Project	<b>IEEE 802.16 Broadband Wireless Access Working Group</b> < <a href="http://ieee802.org/16">http://ieee802.org/16</a> >	
---------	--	--

Title	<b>Periodic ranging in Sleep mode</b>	
-------	---------------------------------------	--

Date Submitted	<b>2004-03-05</b>	
----------------	-------------------	--

Abstract	This contribution is to propose the MOB_TRF IND message in order to perform the periodic ranging within sleep interval.	
----------	---	--

**Figure 1. The proposed operation of sleep mode and periodic ranging**

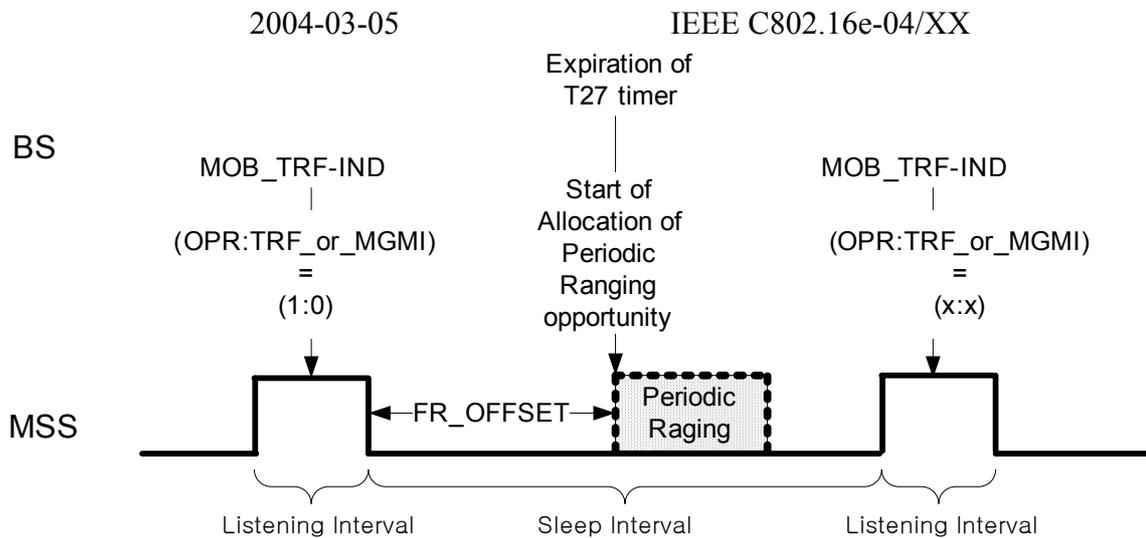
- The additional frame offset(FR\_OFFSET-Frame offset to awake within sleep window for periodic ranging) means
  - If the periodic ranging Operation dose occurs, that is, if BS allocates the uplink burst for periodic ranging in UL-MAP message to MSS in sleep mode, MSS shall enter awake mode within sleep window in order to get the UL burst for periodic ranging. Therefore, MSS has to know when to awake during the sleep window. For this reason, MSS whose OPR is '1', that is, MSS with periodic ranging operation during sleep window shall refer to its own FR\_OFFSET that its unit is frame.
  - MSS whose OPR bit is '1' shall check the ranking among All the MSSs whose OPR bit is '1' and then read its own FR\_OFFSET in the order of SLPID. And then, For power saving, MSS may return to sleep mode until the start of periodic ranging operation apart from end of the listening interval as FR\_OFFSET.

Figure 1 shows the example of the proposed operation of periodic ranging and sleep mode
